**45-DAY EXPRESS TERMS
FOR
PROPOSED BUILDING STANDARDS
OF THE
DIVISION OF THE STATE ARCHITECT – ACCESS COMPLIANCE (DSA-AC)
REGARDING PROPOSED CHANGES TO:**

**2007 CALIFORNIA BUILDING CODE (CBC)
CALIFORNIA CODE OF REGULATIONS, TITLE 24, PART 2**

DSA-AC proposes to:

FIGURE 11B-2A - SHOWER STALLS

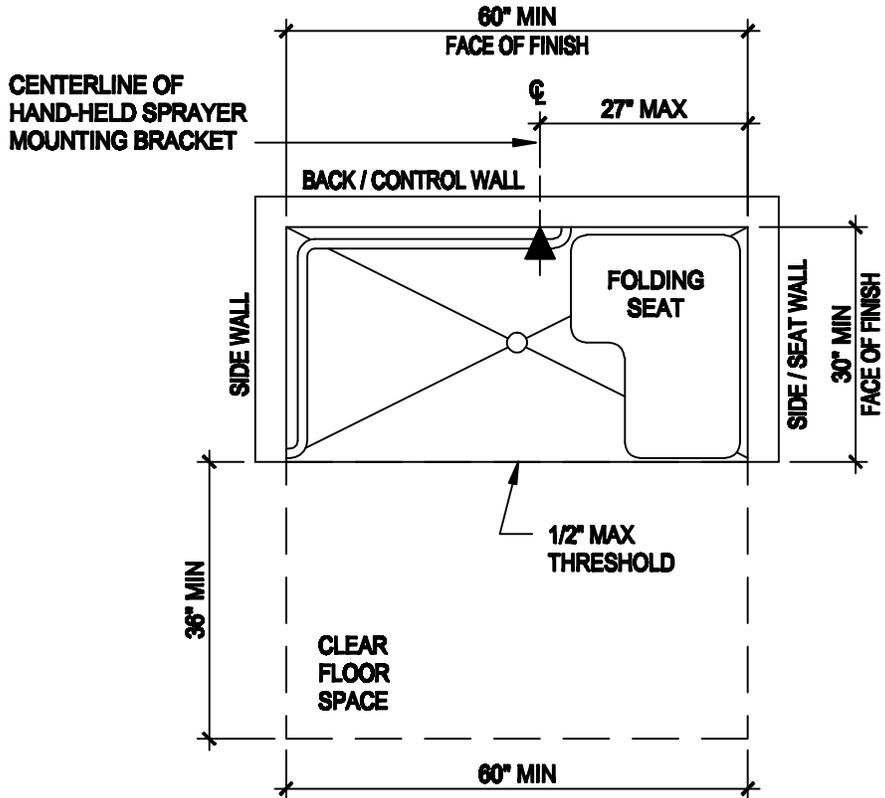
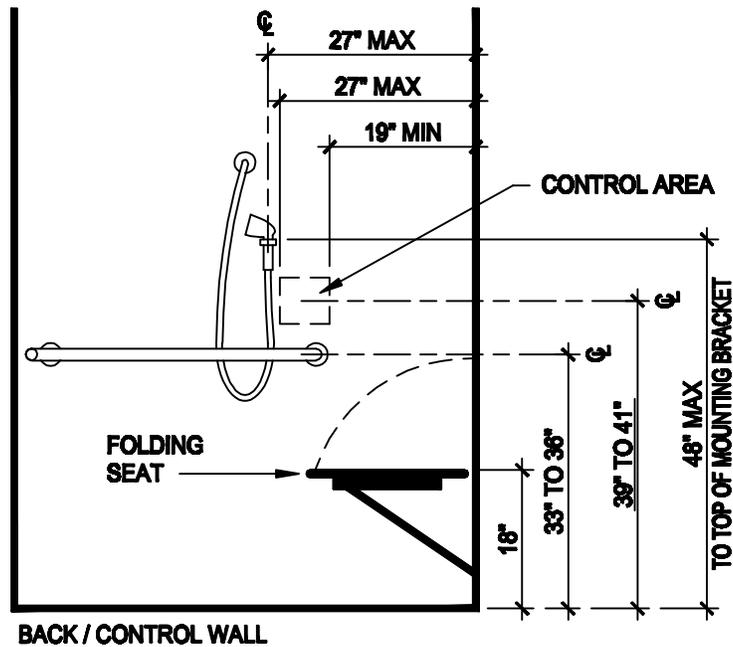
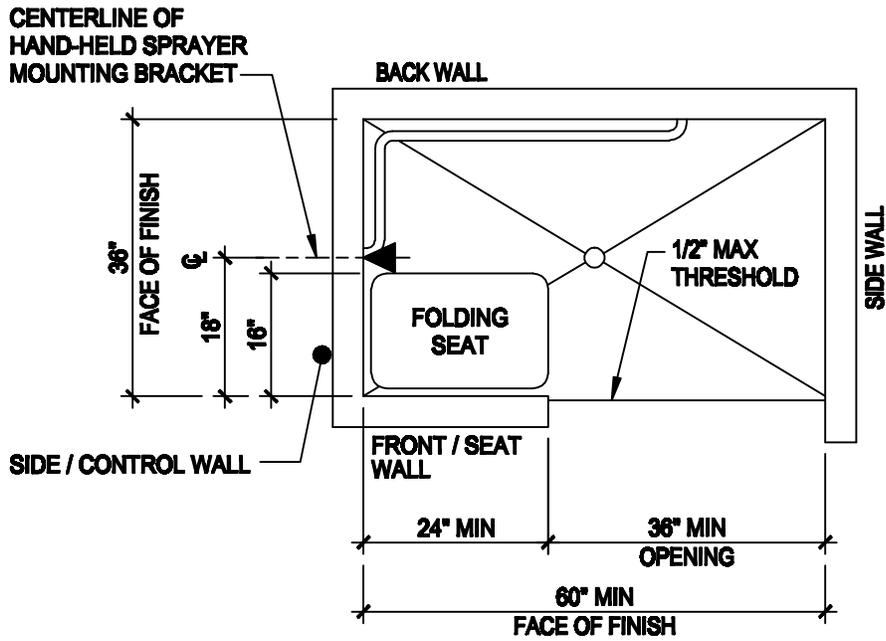
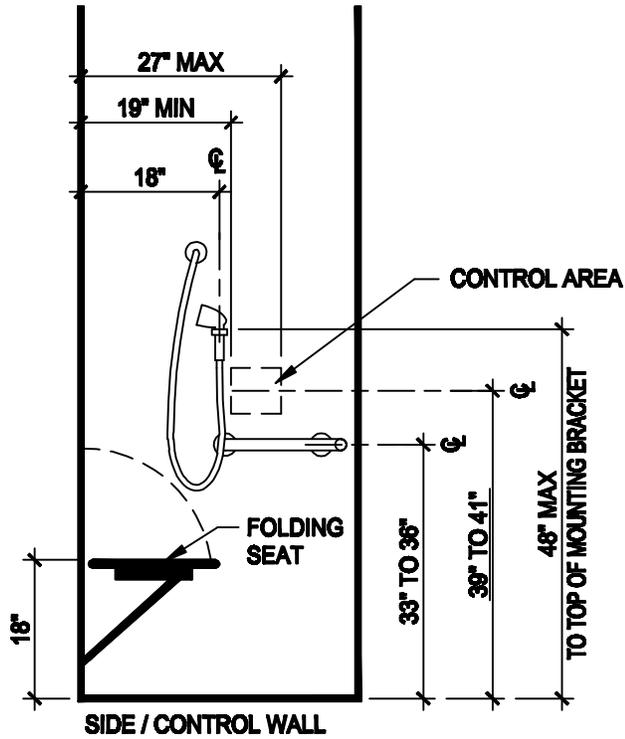
FIGURE 11B-2A SHOWER STALLS

FIGURE 11B-2B - SHOWER STALLS (CONT)

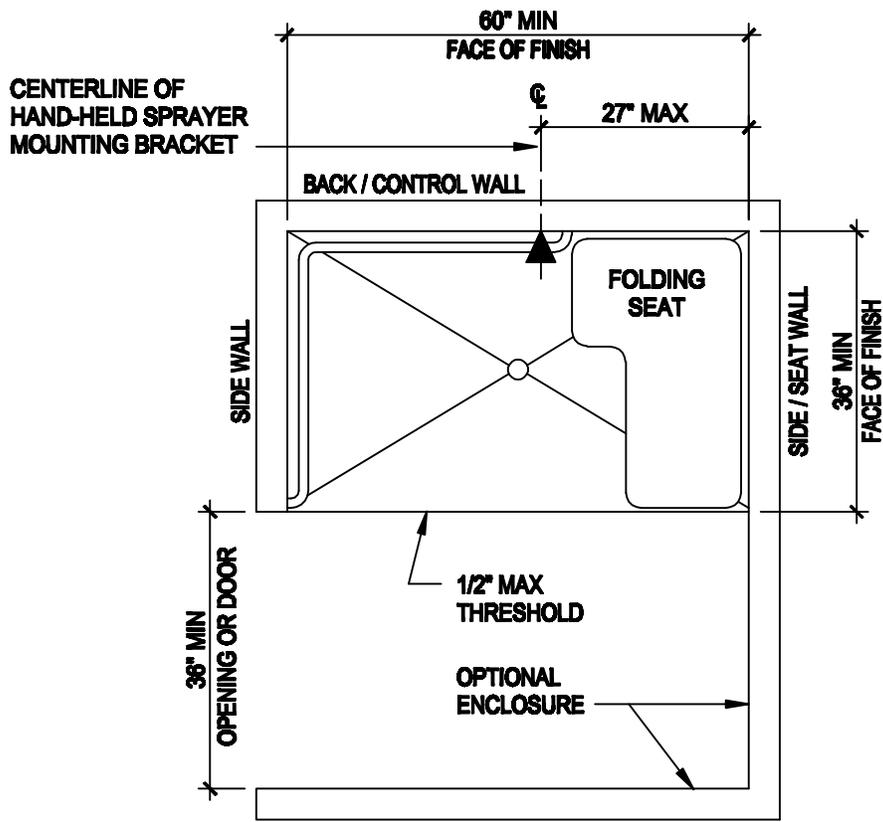
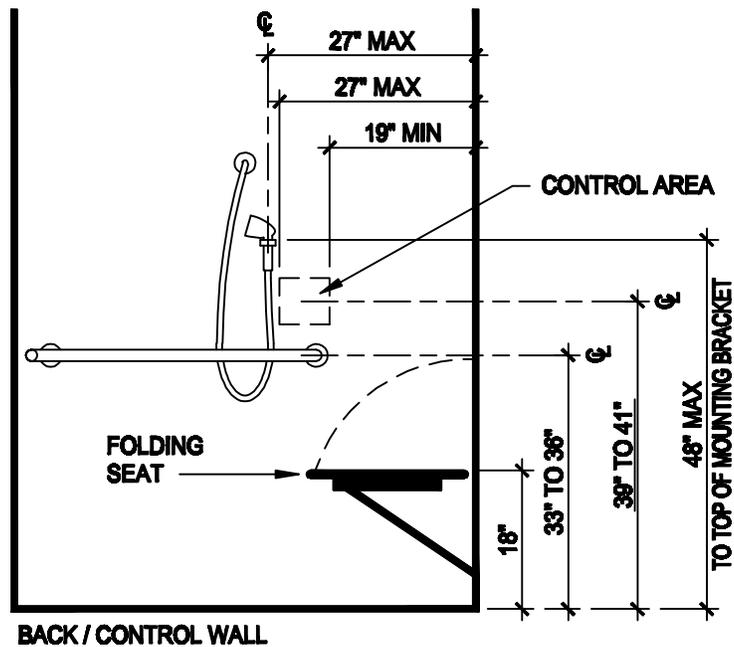
FIGURE 11B-2B SHOWER STALLS (CONT)

FIGURE 11B-2C - SHOWERS STALLS (CONT)

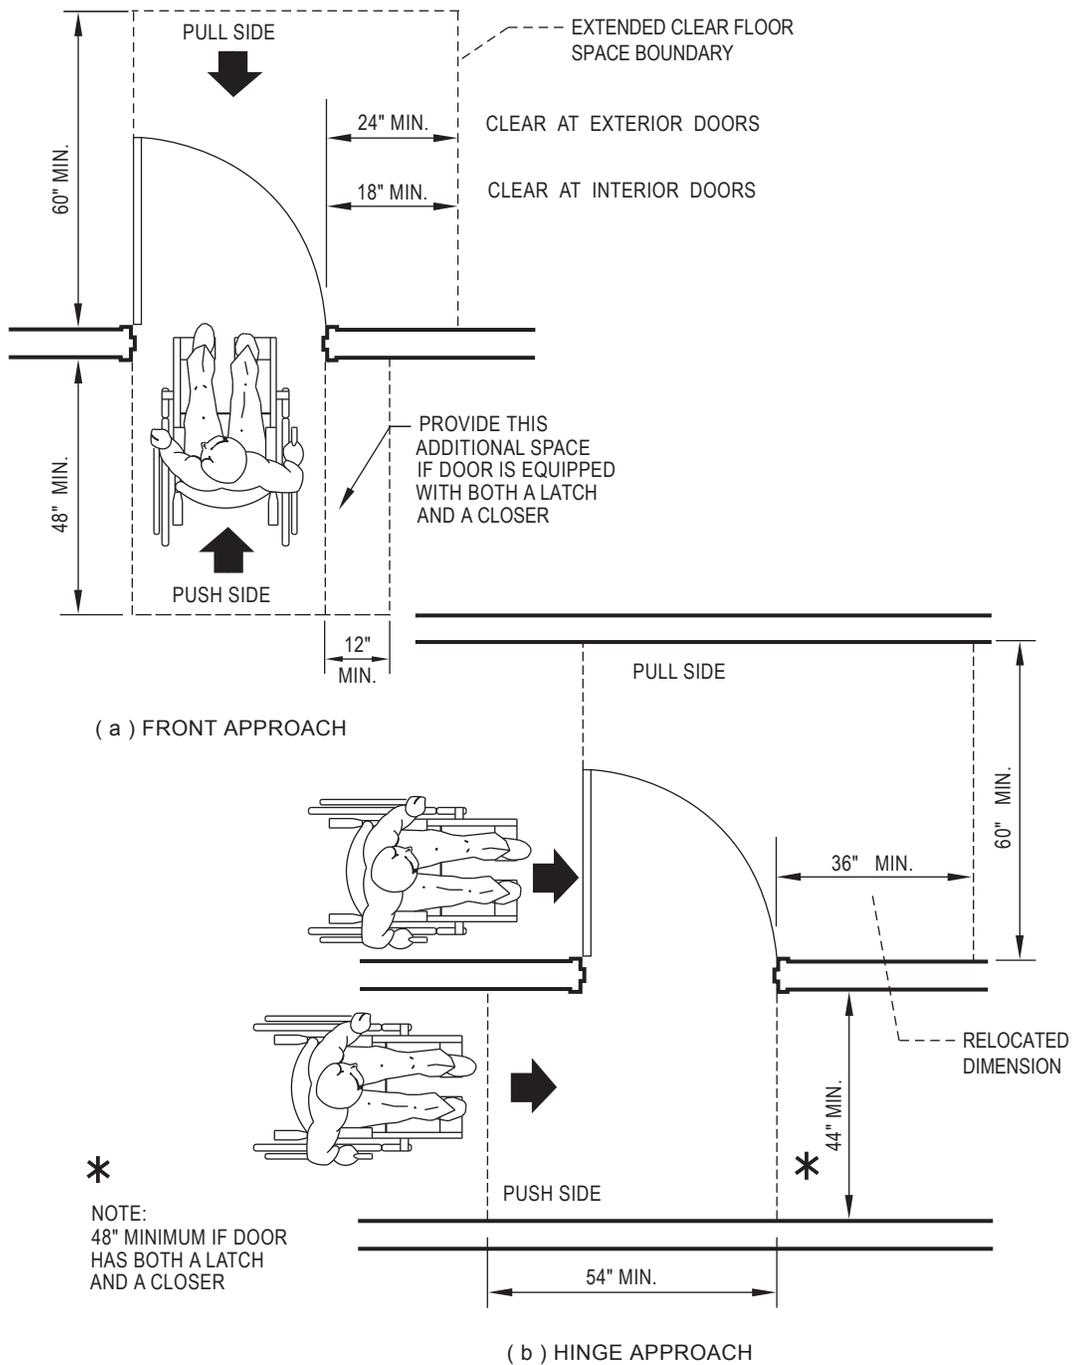
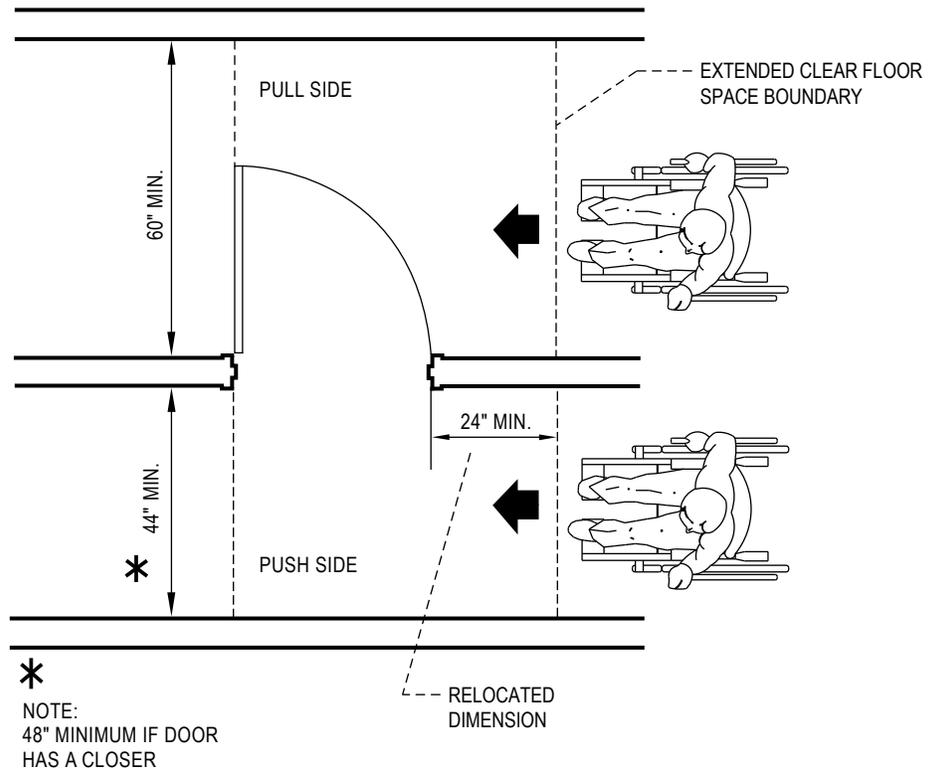
FIGURE 11B-2C SHOWER STALLS (CONT)

FIGURE 11B-26B—LEVEL MANEUVERING CLEARANCE AT DOORS

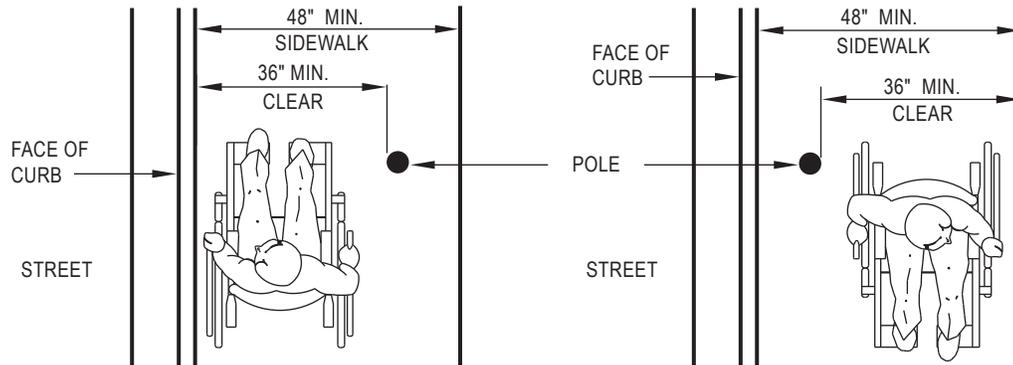
FIGURE 11B-26B LEVEL MANEUVERING CLEARANCE AT DOORS

FIGURE 11B-27—RAMPS AND SIDEWALKS

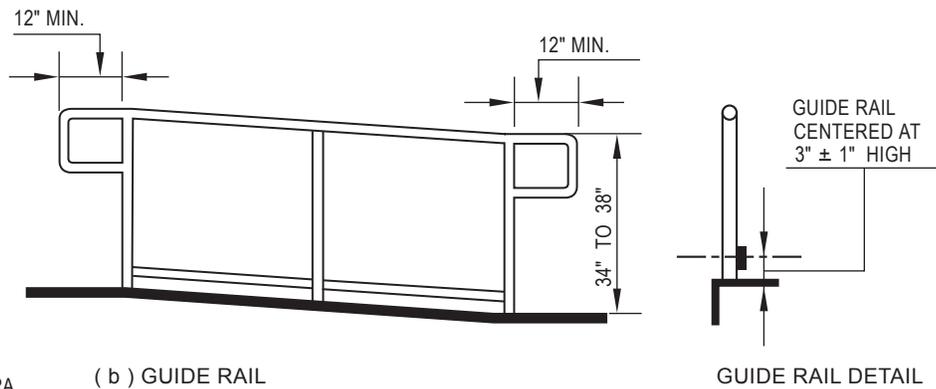
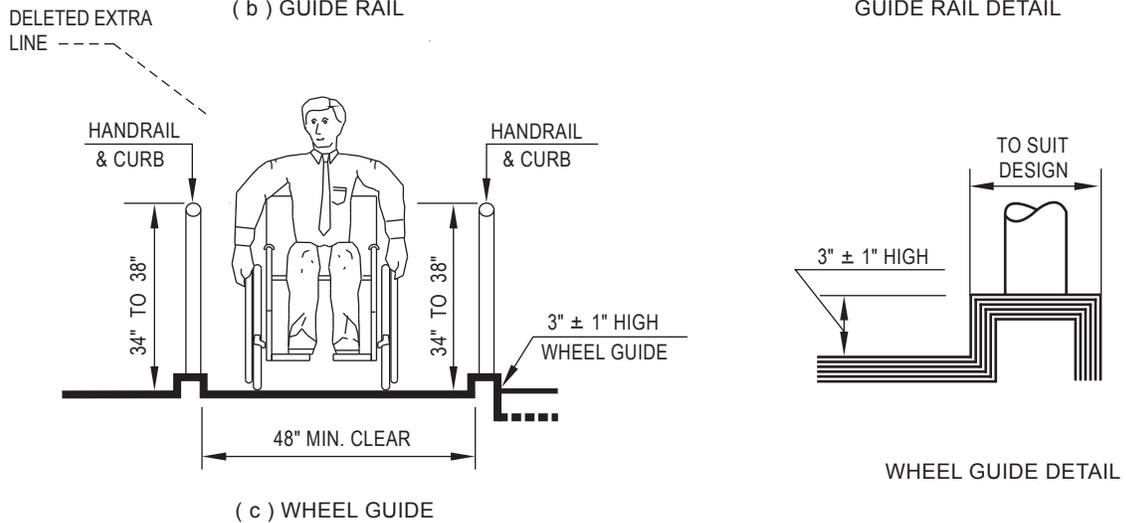
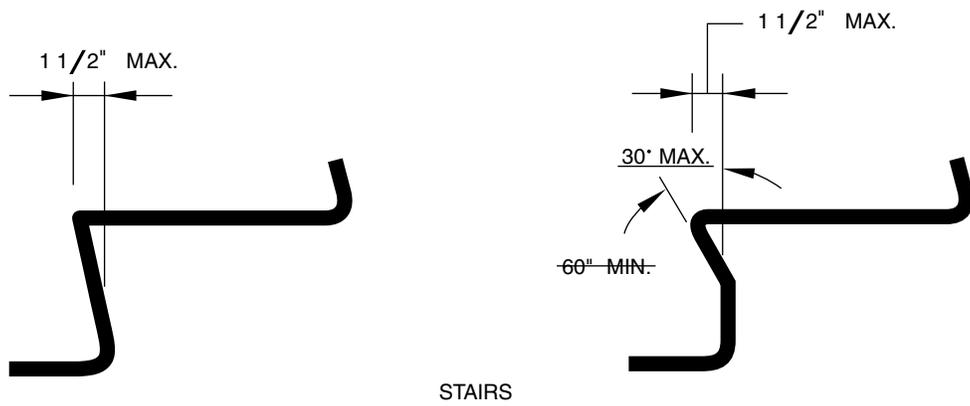
FIGURE 11B-27 RAMPS AND SIDEWALKS

FIGURE 11B-35—WARNING STRIPING AND HANDRAIL EXTENSIONS

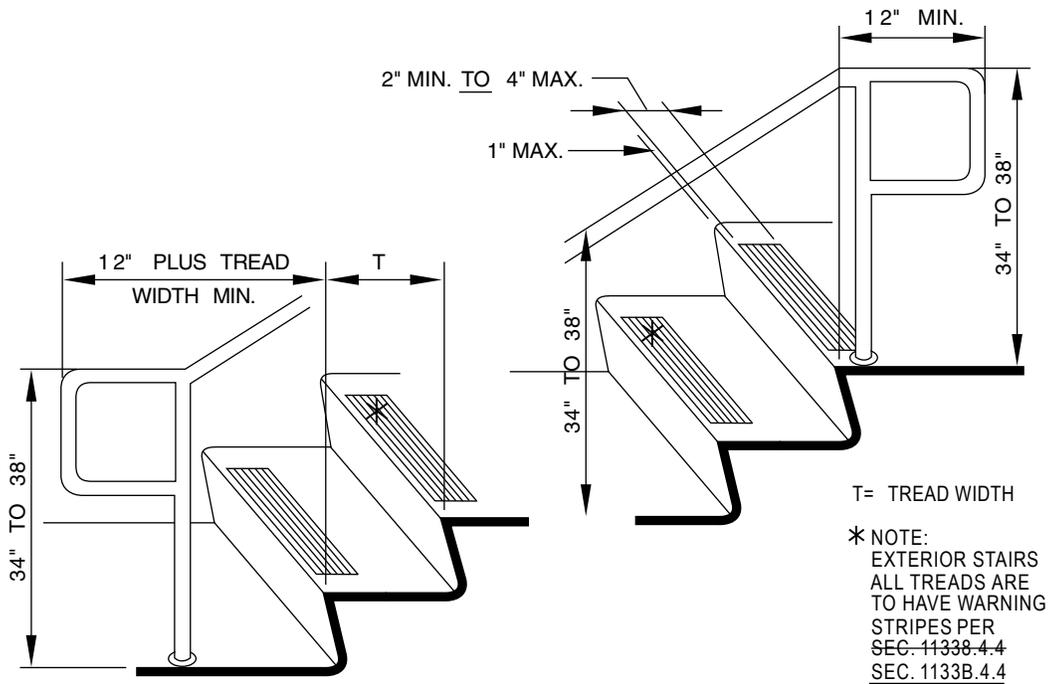
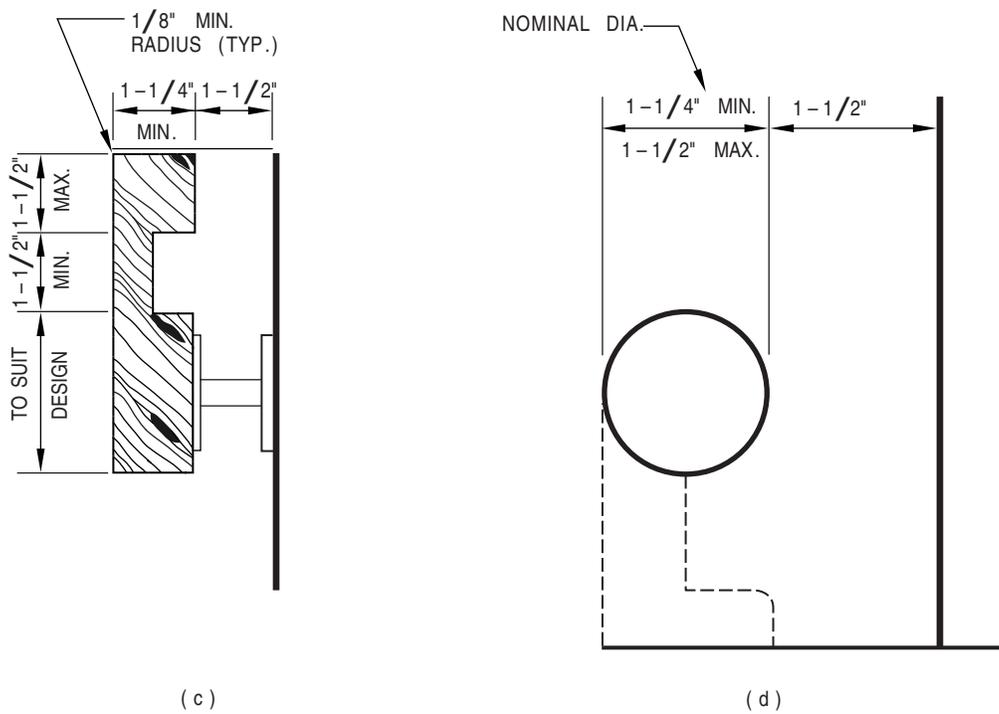
FIGURE 11B-35 WARNING STRIPING AND HANDRAIL EXTENSIONS

FIGURE 11B-36—STAIR HANDRAILS

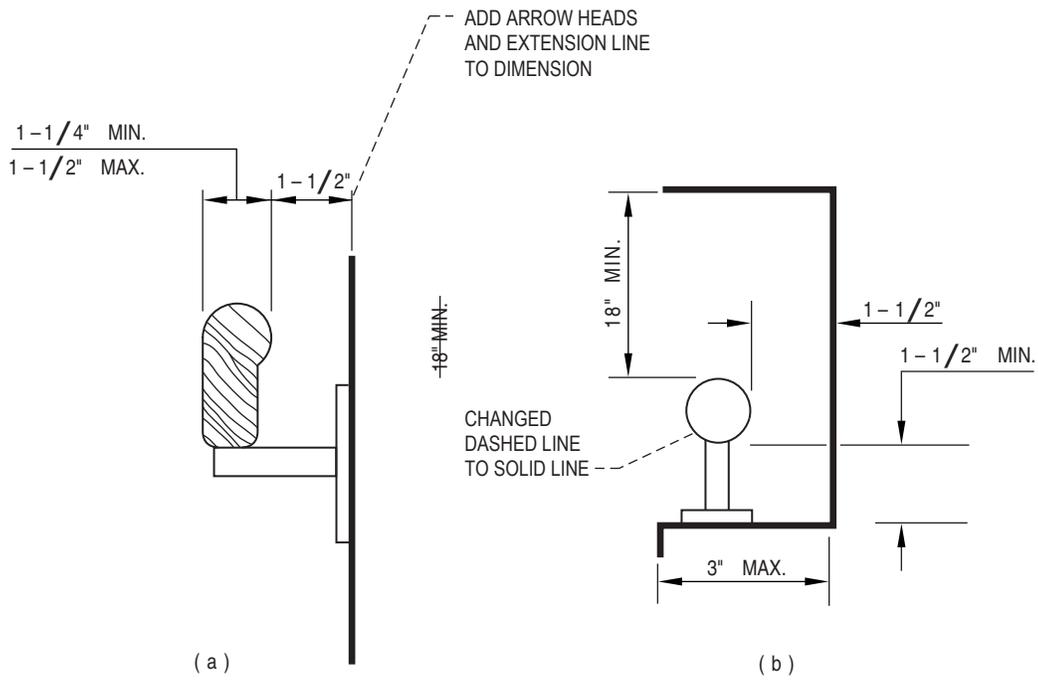
FIGURE 11B-36 STAIR HANDRAILS
